701 VALLEY STREET

MULTI-FAMILY RESIDENTIAL BUILDING

RESPONSE TO EARLY DESIGN GUIDANCE

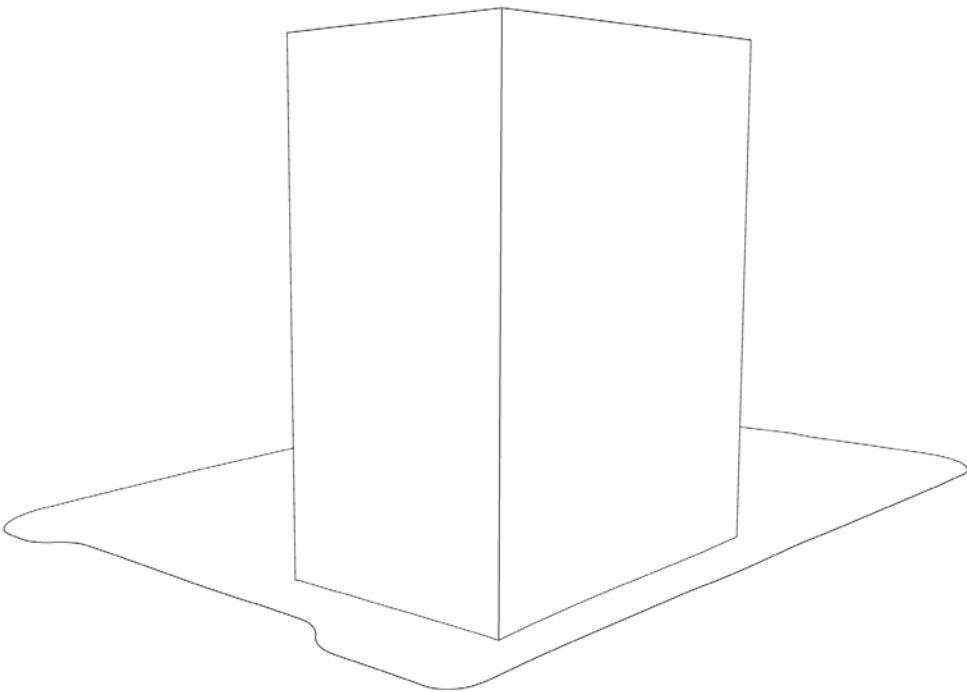
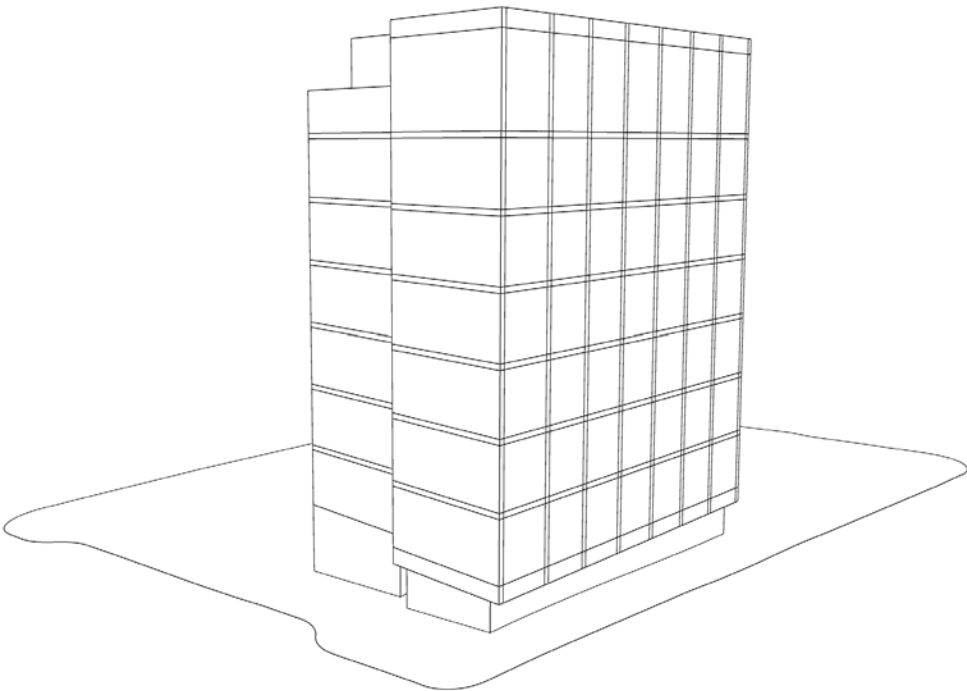
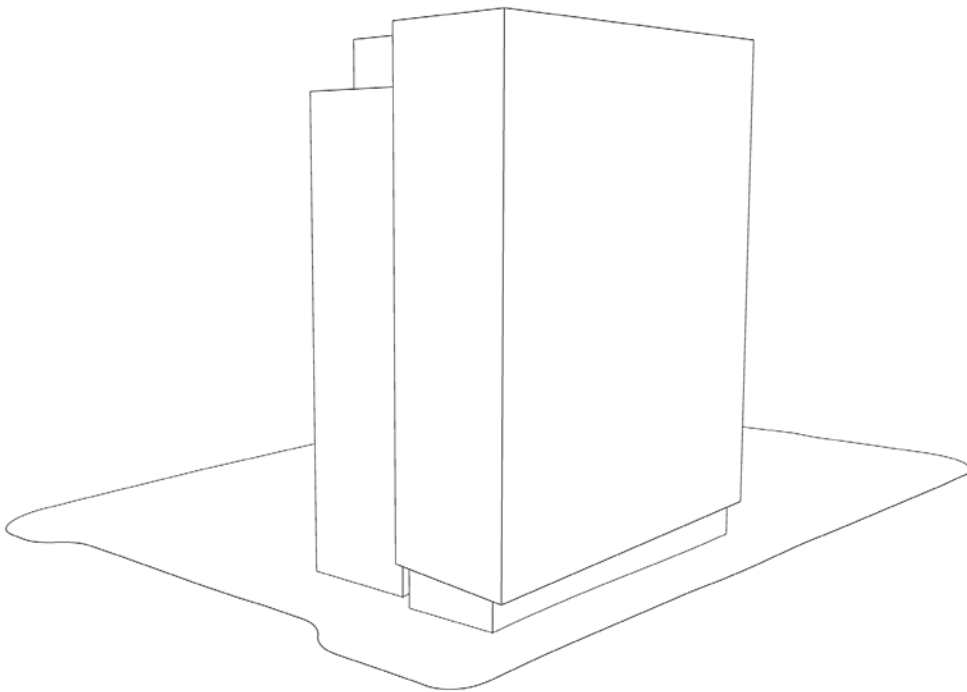
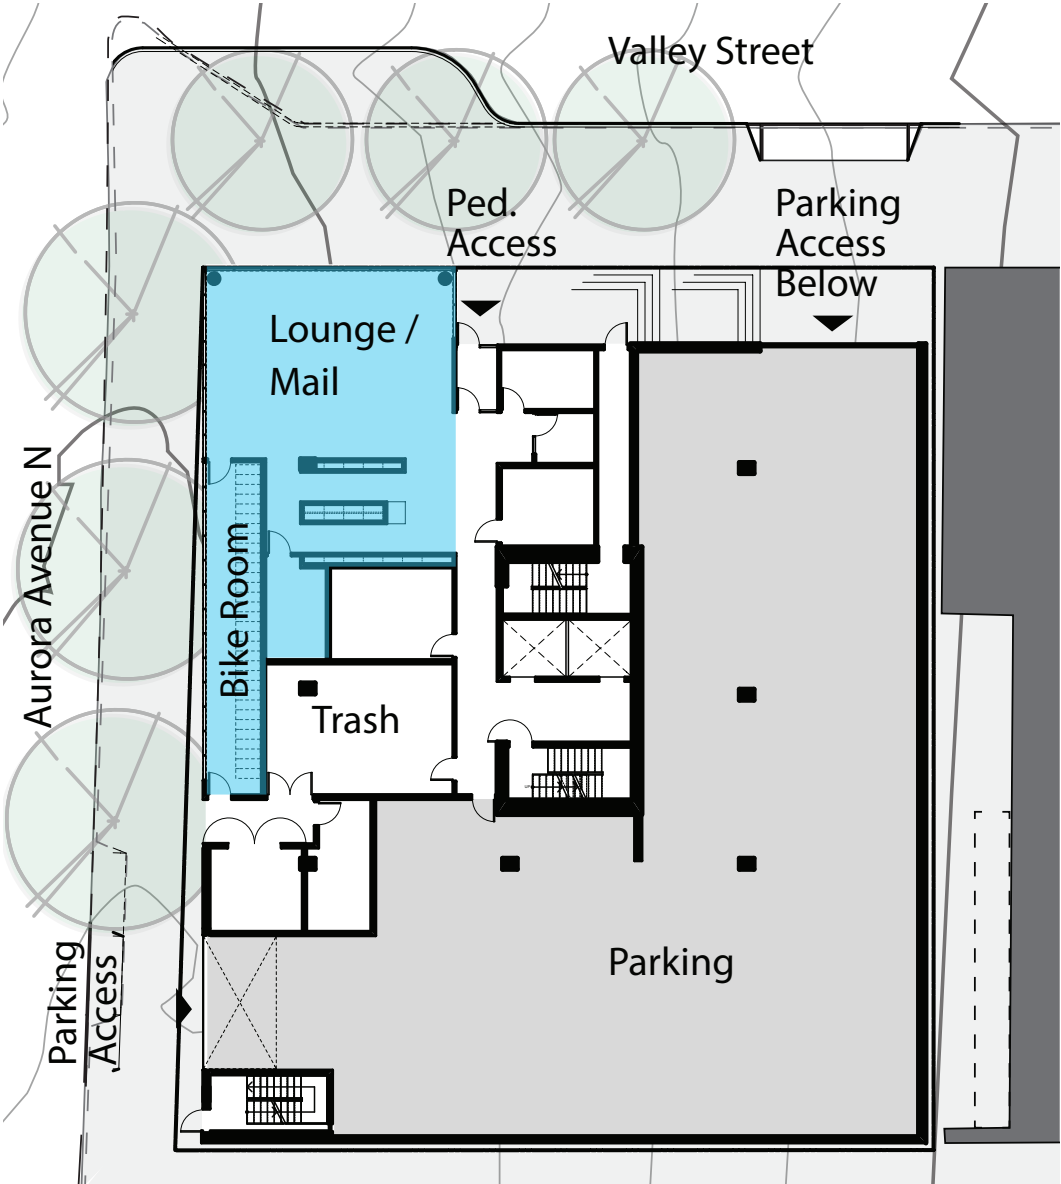
1 MASSING
The Board directed the applicant to proceed with the preferred option as it has a better relationship to the surrounding structures and provides better open space for residents. The Board supported the orientation of the residential units facing west and east, and also pulling the massing away from the neighboring existing structures. The Board recommended the design team locate the structure to set a precedent for orientation for views and the treatment of Aurora Ave N.

The Board noted the top of the structure will be visible, and expressed it was up to the design team to decide if the east or west location for the amenity and open space on the roof is the best location. The Board supported the modulation on the north and south elevations, and requested that the west elevation use secondary architectural features to create a finer human scale detailing. The Board recommended designing the tower so it has a residential appearance and character.

Response: The slender tower and shift in plan minimizes the profile of the building as seen from from Aurora Ave N and Queen Anne Hill. Additionally, a step in the building’s massing at the rooftop creates an east-oriented roof terrace. Because of building code requirements limiting the opacity of walls proximate to property lines, and the energy code’s limits on glazing, the design strategy for the residential slabs is to maximize glazing on the east and west elevations, while treating the relatively short, north and south elevations as mostly opaque with limited punched openings. While the pedestrian entrance is oriented to Valley Street, the building uses its massing to addresses Aurora Avenue, its most visible exposure, with a strong edge, and an identifiable, activated lobby use at the street level. With its stepped and shifted residential slabs, the building establishes a neighborhood precedent for urban architecture that responds to both topography and the dynamic flight path overlay, while maintaining clear expressions of its program

Response: The building is divided into masses that shift in plan and step in elevation in direct response to the sites topography and urban context. The residential units are contained in slender volumes organized about a corridor. Balancing views with the desire for privacy, the volumnas are expressed as a combination of opaque panels and generous windows. Opaque walls are concentrated at the north and south elevations, providing generous floor to ceiling view windows in all units. Common spaces, such as the corridors, residential lobby, and rooftop amenity area are recessed, contiguous, and expressed with a contrasting material palatte of mostly glass and aluminum. The scale of the residences, and the cellular nature of grouping the opaque elements will provide a variety of scales and textures to increase the visual interest of the façades and will express a scale understood to reflect residential design. The different unit layouts on east and west orientations, the proportions, and the presence of the rooftop amenity area will help to differentiate the east façade as a secondary expression relative to the more prominent west façade.

UPDATED STREET LEVEL PLAN

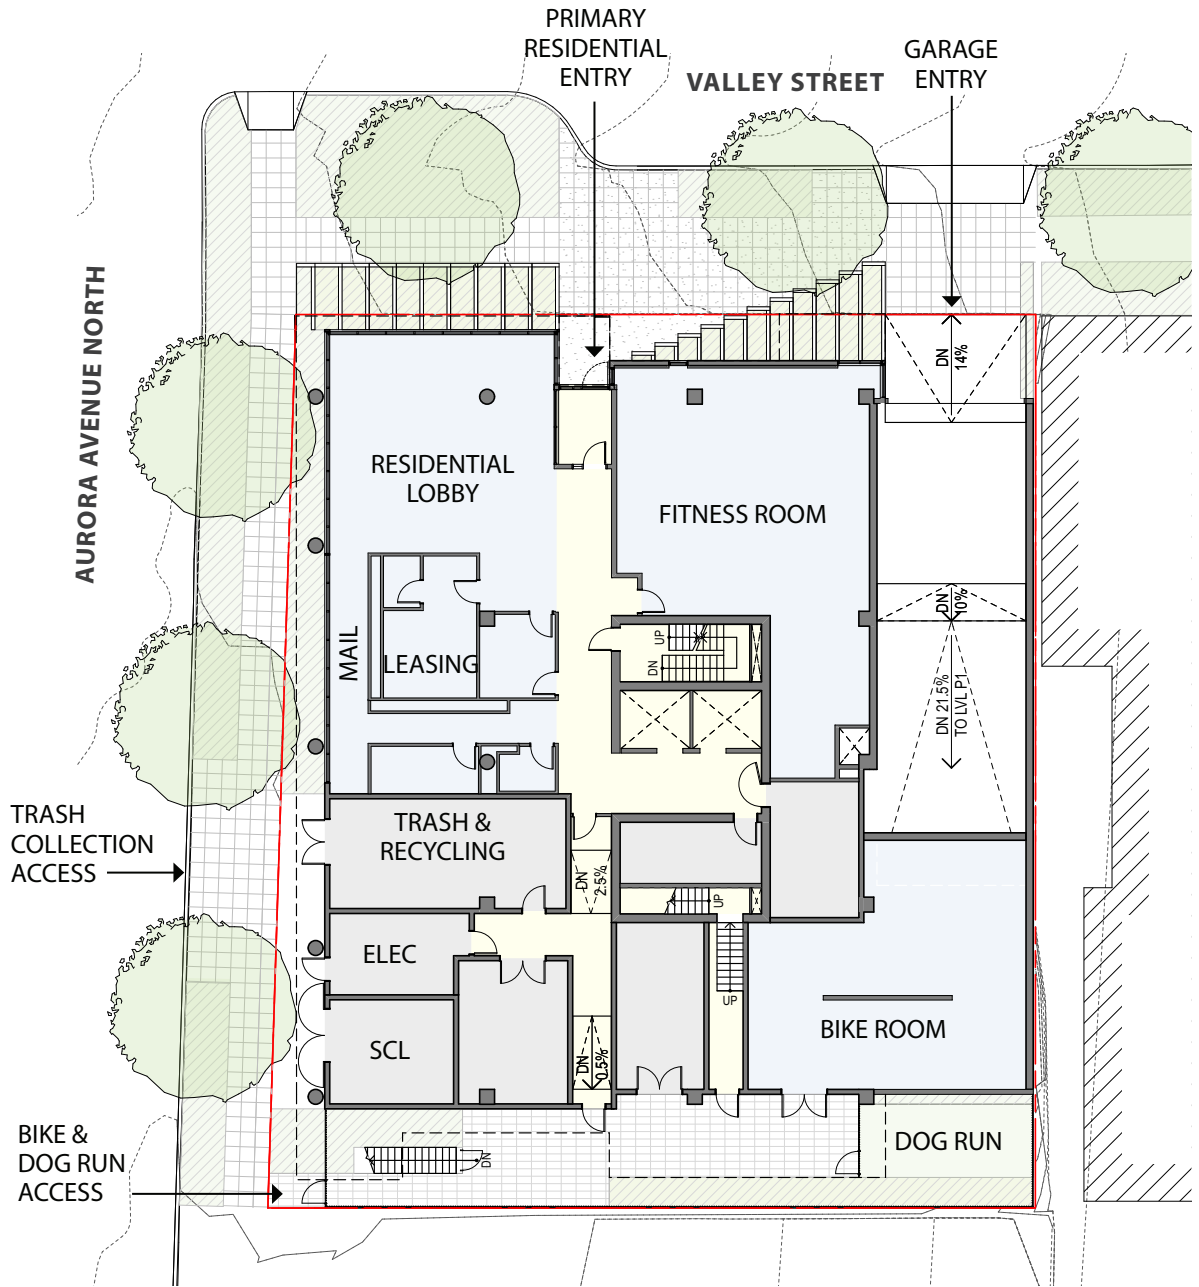
3 RELATIONSHIP TO STREET
The Board encouraged the location of the entry lobby and the cascading stairs towards Dexter Ave N. The Board recommendation prioritizing the street level for residents to enter and exit the site safely. The Board supported the placement of bike storage along Aurora Ave N, and requested careful consideration of how the street edge will work.

4 ACCESS
The Board discussed the departure request to allow a second curb cut off of Aurora Ave N, and noted that they would not be inclined to grant this departure. The Board acknowledged that a curb cut for solid waste pickup only may facilitate pullover space and access for collection trucks. However, they expressed that the solution to this should be determined by SPU, SDOT and DPD.

Response: The primary pedestrian entry is located on Valley Street, clearly marked by the building's massing. Given that most pedestrians arriving to the side will be coming uphill from Dexter Avenue to the east, this lobby entrance is both convenient and visible. The stepped landscaped planters also serve to guide the pedestrians to the entrance. A pedestrian access gate at the southwest corner of the site along Aurora Ave provides access to the rear courtyard, dog run, garage stairs, and bicycle storage room.

Response: Parking garage access is provided from Valley Street at the north of the site. Access to the solid waste pick-up is located on Aurora Ave at the southern end of the site to provide separation from the entry lobby. Solid waste pick-up access off of Aurora and associated curb modification has been reviewed and supported by SPU. The design team is no longer requesting a departure for a curb cut off of Aurora.

1 Main Entry off Valley St

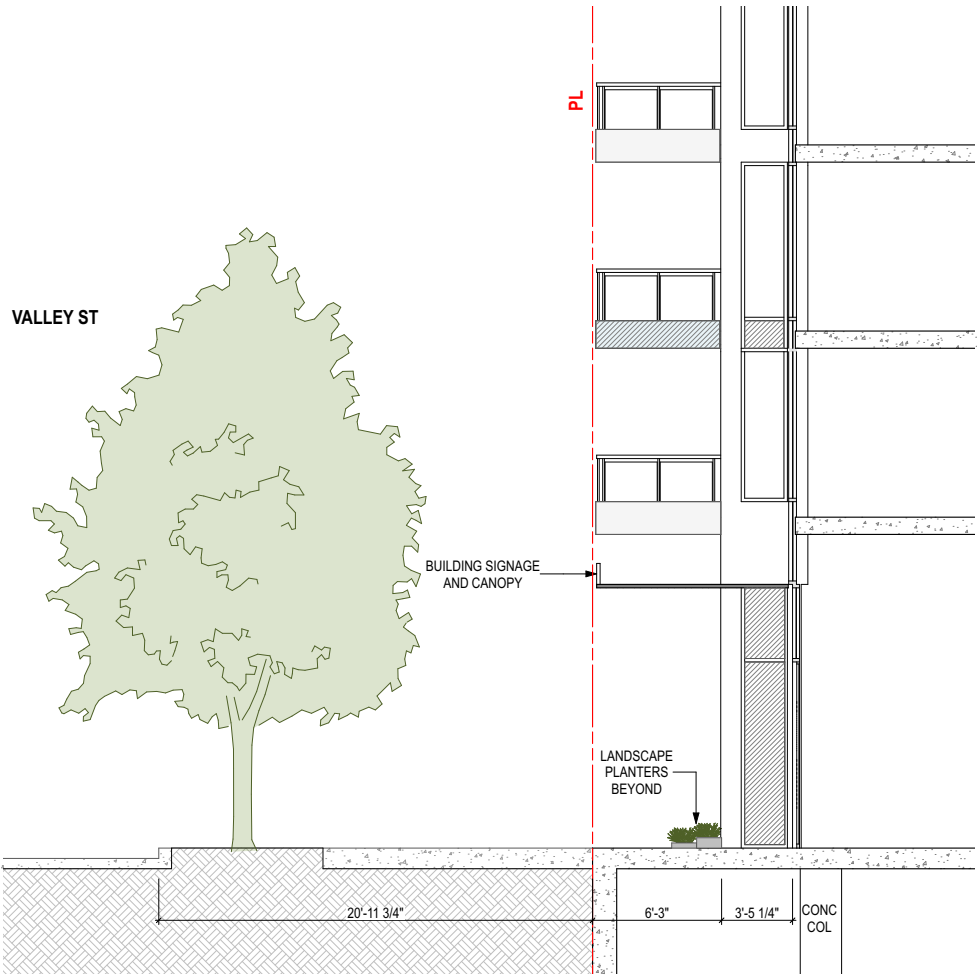
a. The Board encouraged the location of the entry lobby and the cascading stairs towards Dexter Ave N. (CS2.B.2, PL2.A.2, PL3.A.1&2&4)

Design Response: The primary pedestrian entry is located on Valley Street, clearly marked by the building's massing. Given that most pedestrians arriving to the side will be coming uphill from Dexter Avenue to the east, this lobby entrance is both convenient and visible. The stepped landscaped planters also serve to guide the pedestrians to the entrance.

2 Garage Entry off Valley St

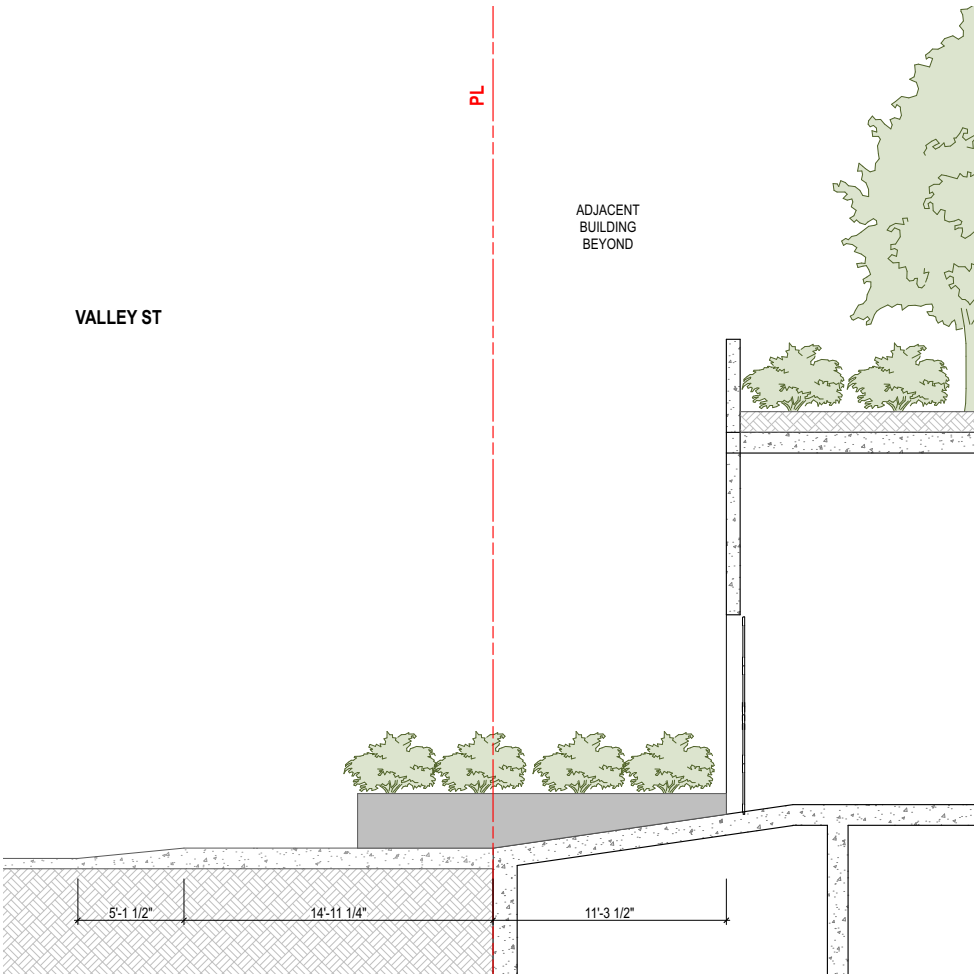
b. Design the street level for residents to enter and exit the site safely. (PL2.A.2, PL2.B.3, PL3.A.1&2, PL4.A.2, DC1.B.1)

Design Response: The main pedestrian entry is located on Valley street to provide a safe entry. Conversely, the noise and traffic associated with Aurora Avenue would have made it or the corner an unsuitable location for a pedestrian entry. Locating the SCL vault and Solid Waste access on Aurora helps to separate pedestrian access from these uses. The entry to the parking garage is also located on Valley St, but the curbs, planting, and pavement texture are designed to enhance the pedestrian experience, and increase the awareness that cars are approaching a pedestrian trafficked area.

3 South Courtyard off Aurora Ave N

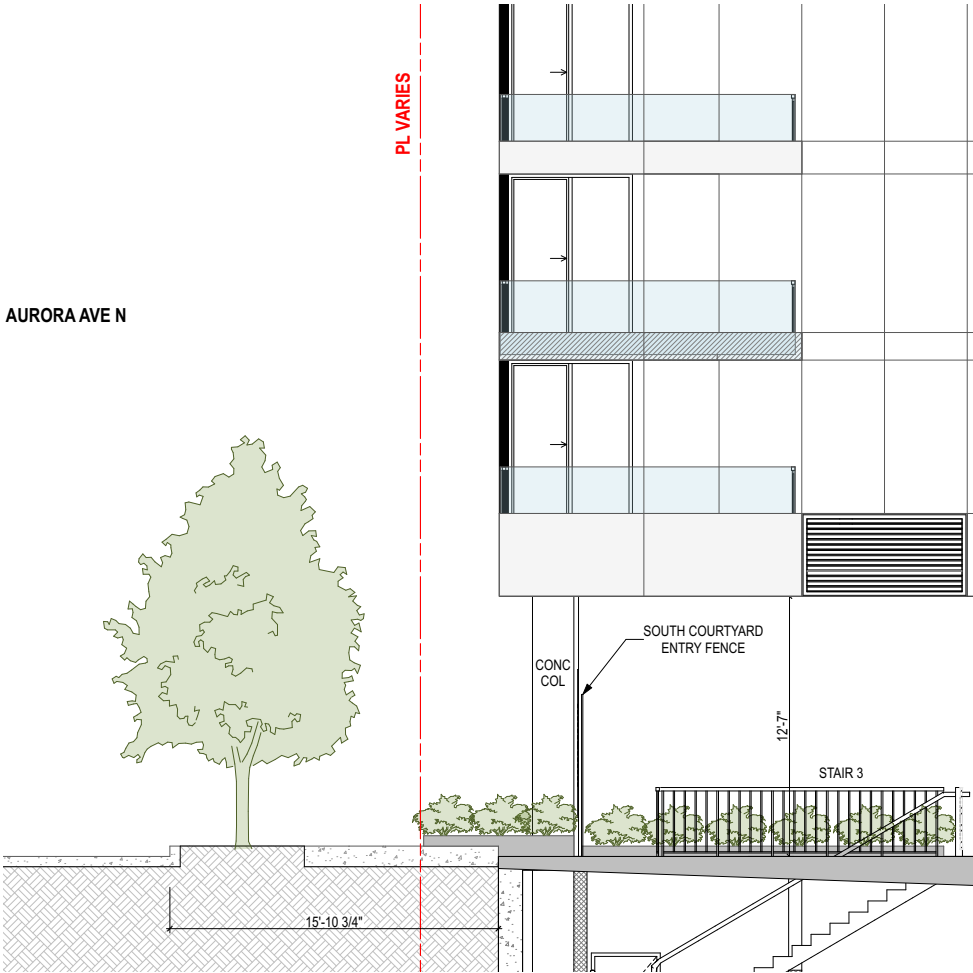
c. Supported the placement of bike storage use along Aurora Ave N. (PL4.A.1, DC1.A.4)

Design Response: The site contains a secondary pedestrian access gate at the southwest corner of the site along Aurora. This gate connects to the rear courtyard, which provides access to the bicycle room, dog run and garage stairs. Resident bicyclists or dog walkers arriving from the south may elect to come up Roy Street, which has a more gradual grade than Valley Street.

4 Residential Lobby Along Aurora

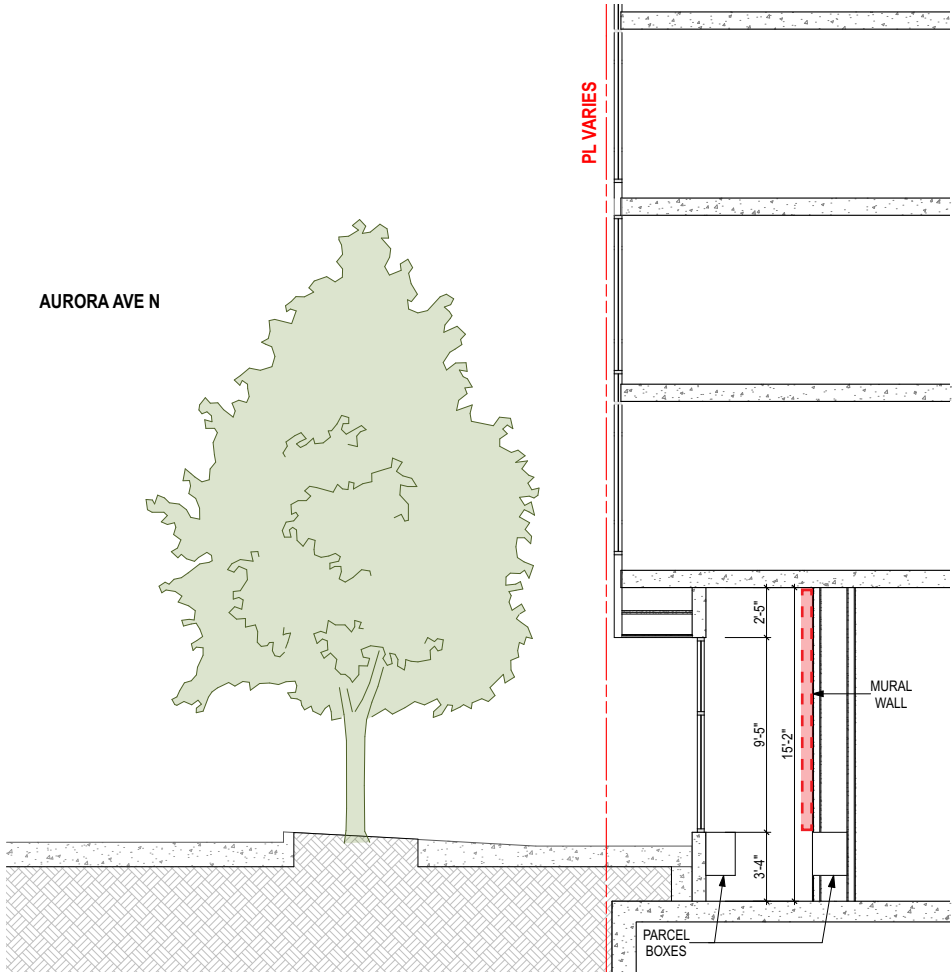
d. Carefully consider how the street edge will work. (DC2.A.1, DC2.B.1&2)

Design Response: As a welcoming gesture to pedestrians, the sidewalk planters step up the steep hill while shifting back towards the building and its entrance. The western residential slab has been shifted up on columns, revealing the common areas of the lobby level as a continuous horizontal gasket open to the public, pedestrian realm.
